Fixed Sound Absorptive Wood Panels

JOB: Webster ISB
JOB NO: I-55453-098413
SHIP TO ADDRESS: 8724 Big Bend Blvd
StLouis, MO 63119

PROJECT: 15051-Webster University Interdisciplinary Science Building

RE: Soundply Sound Absorptive Wood Panel
Shop Drawings

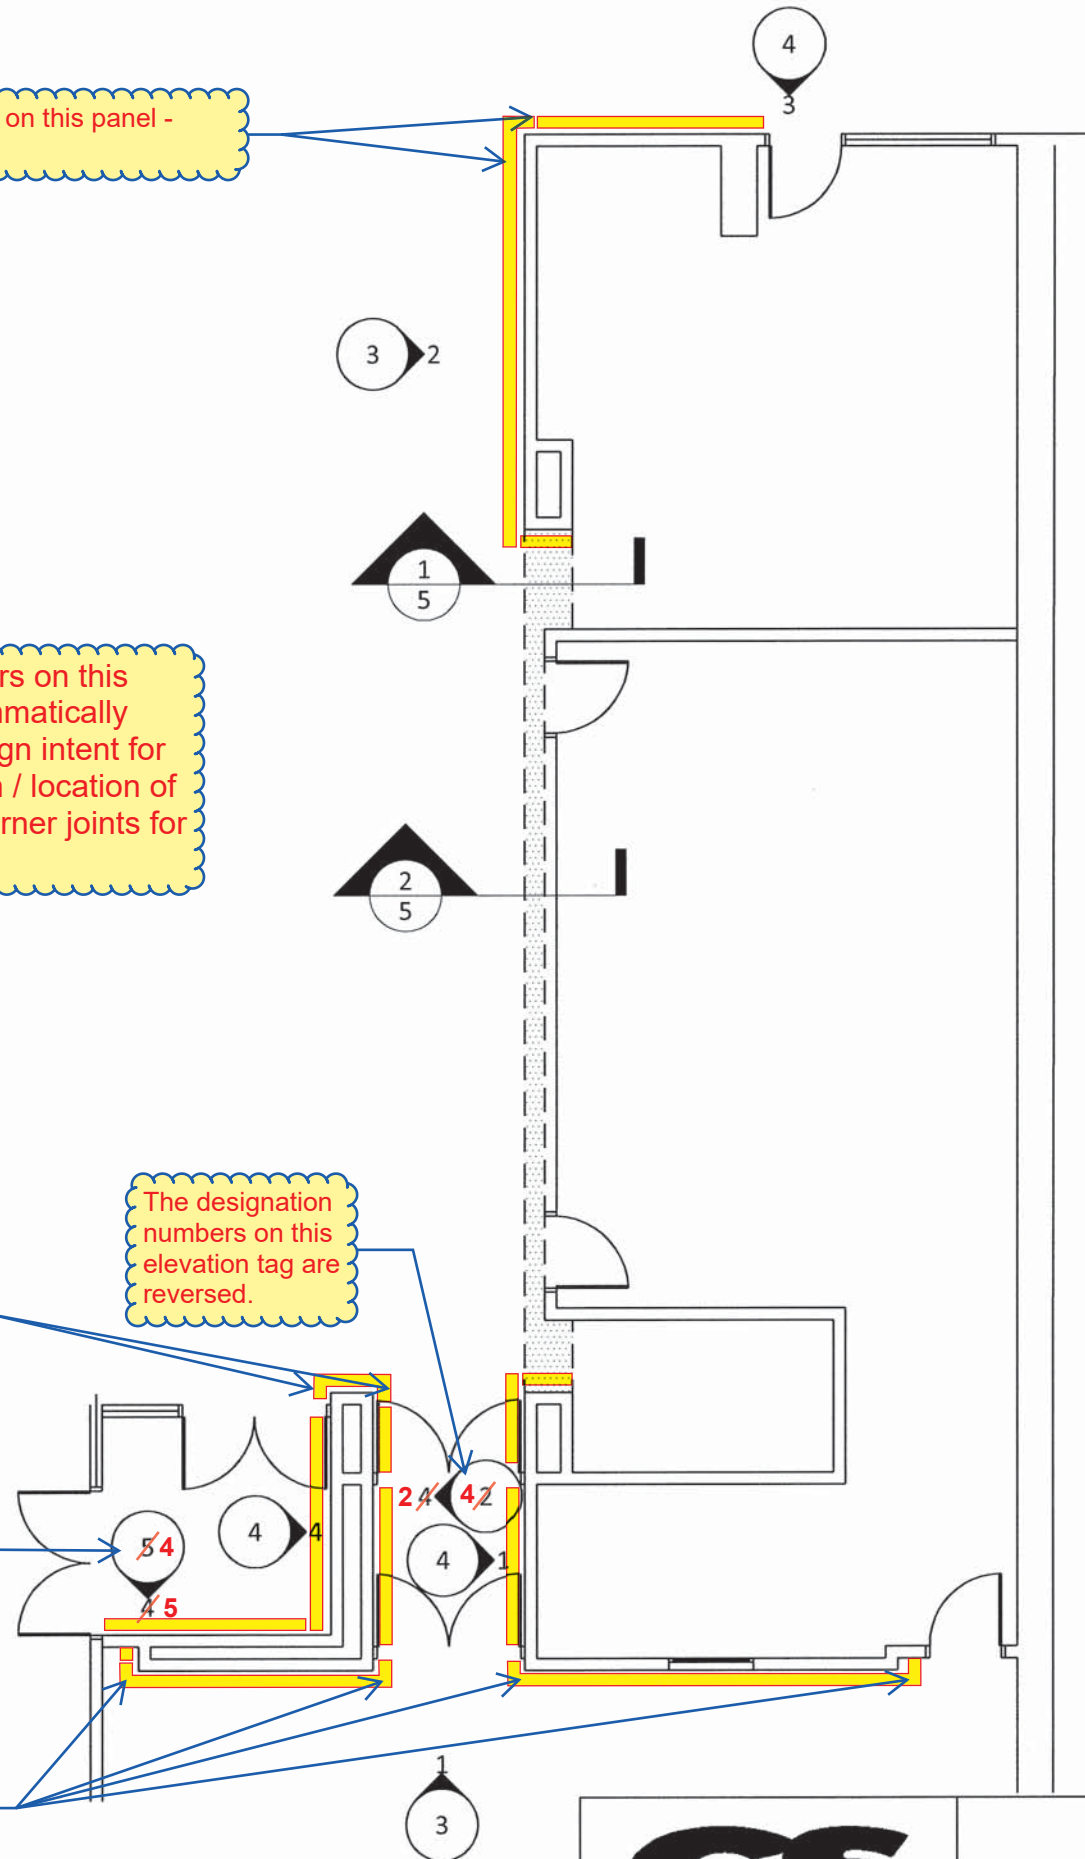
Provide return on this panel - refer to details

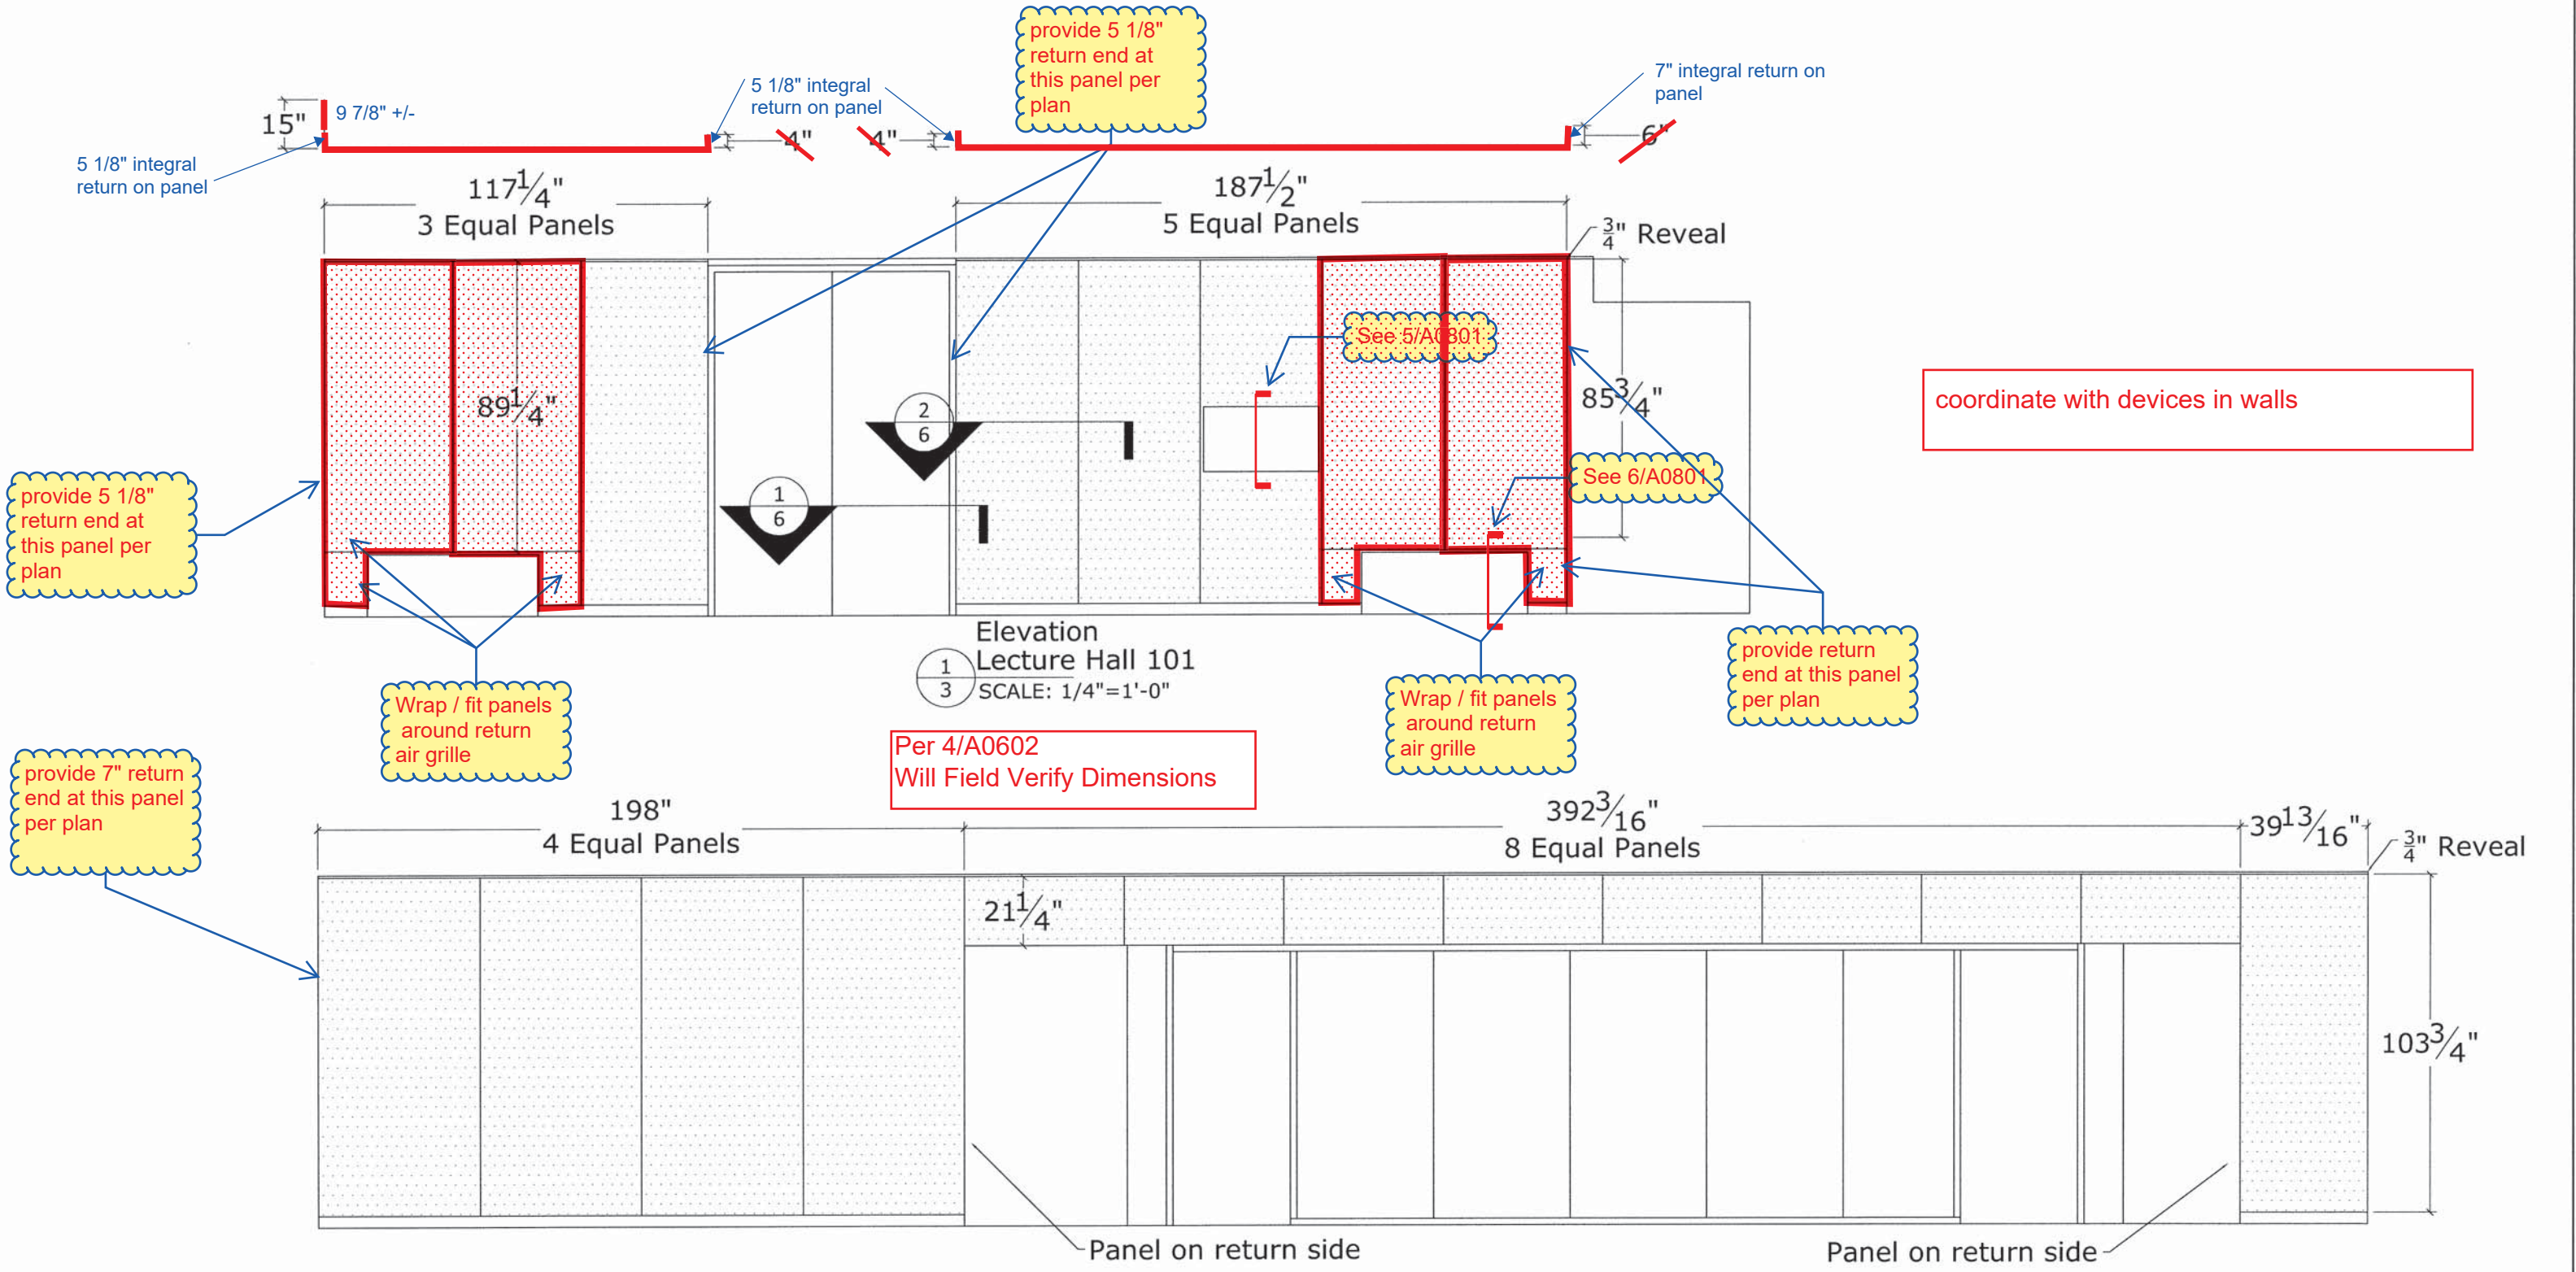
The yellow bars on this sheet diagrammatically show the design intent for the orientation / location of the outside corner joints for these panels.

Provide returns on both sides of this panel - refer to details

The designation numbers on this elevation tag are reversed.

Provide 5 1/8" returns on all these panels - refer to details

Per A0202

(panel shown on
elevation 2 sheet 3)

Section View
Soffit
1
5 SCALE: No Scale

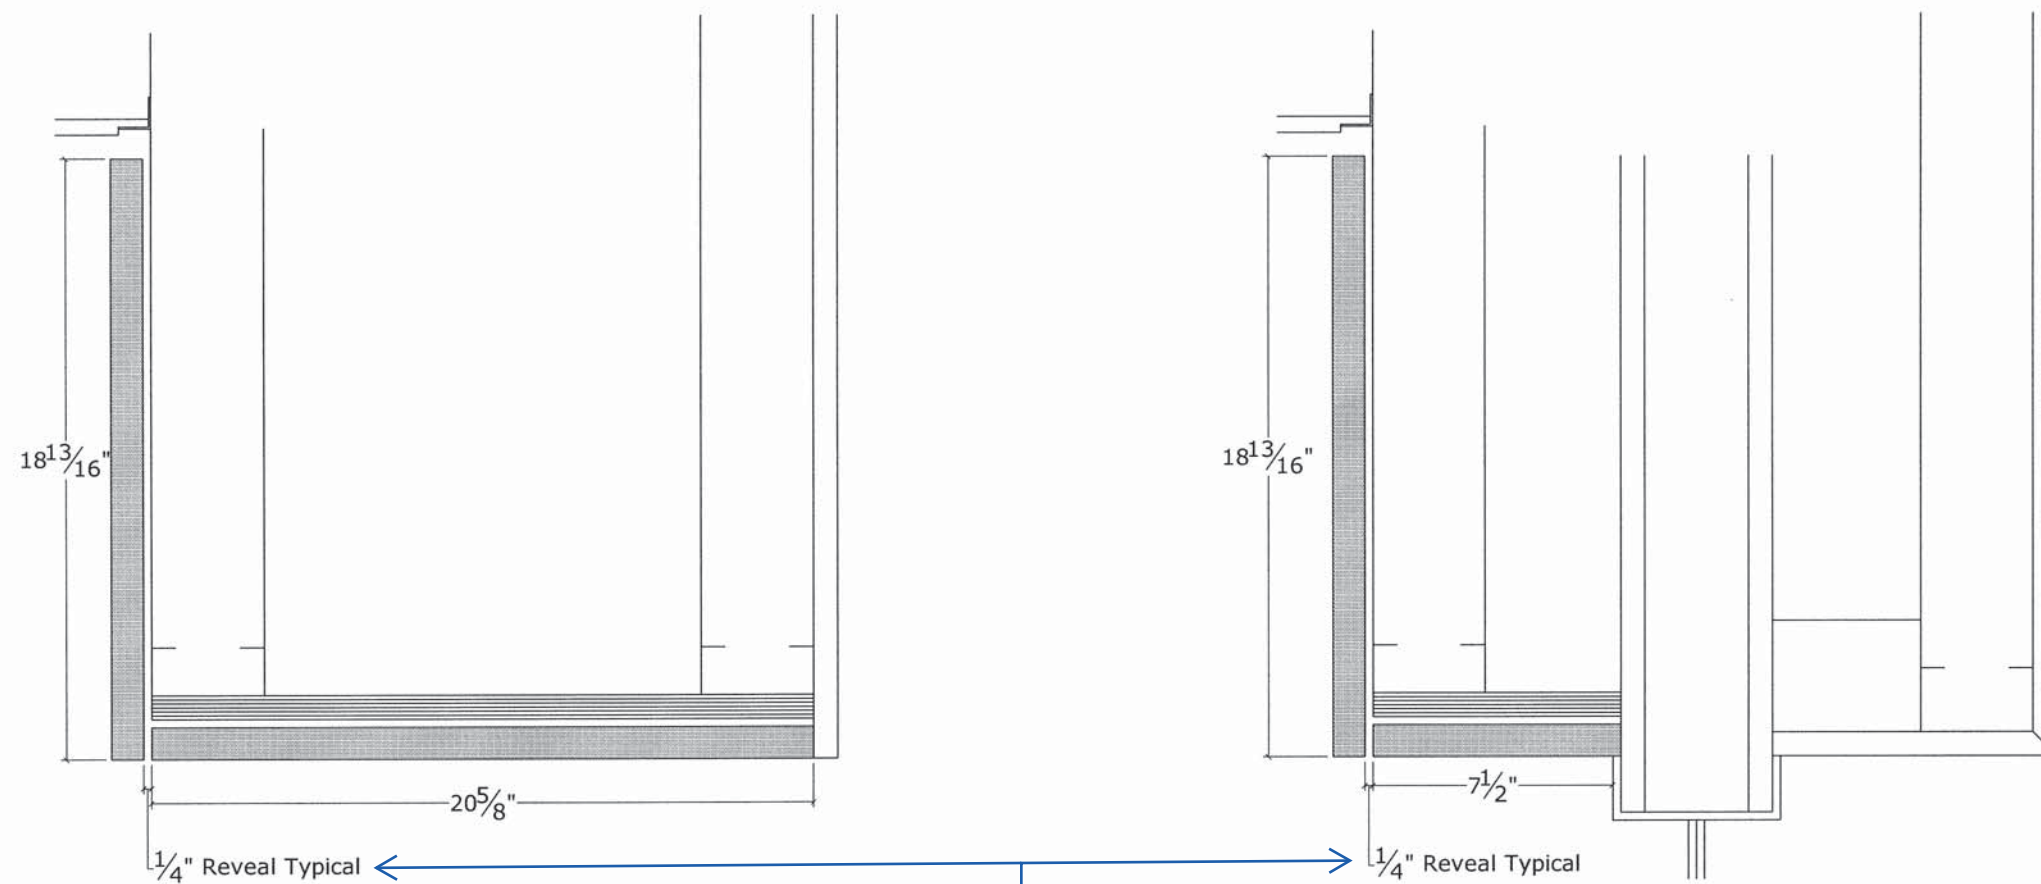
coordinate with devices in walls

Please use 1/8"
reveal here instead
of the 1/4" reveal.

Will field verify dimensions prior to fabrication.

1
6 Typical Detail
Outside Corner
SCALE: No Scale

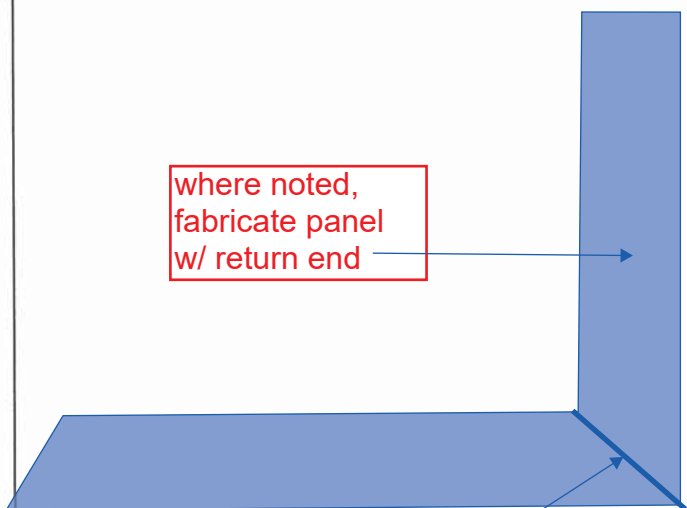
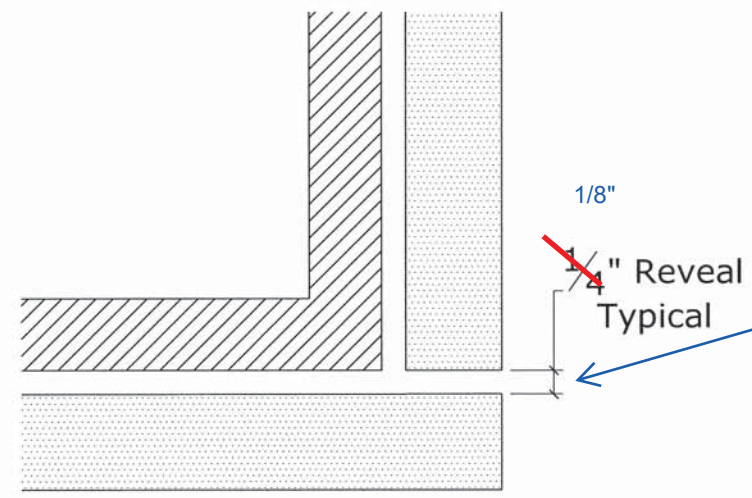
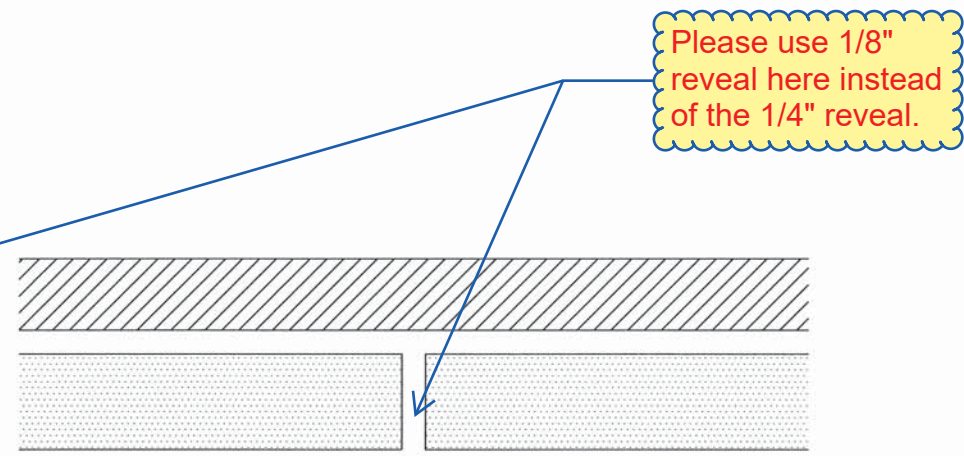
where noted,
fabricate panel
w/ return end

miter panel

Please use 1/8"
reveal here instead
of the 1/4" reveal.

Will field verify dimensions prior to fabrication.
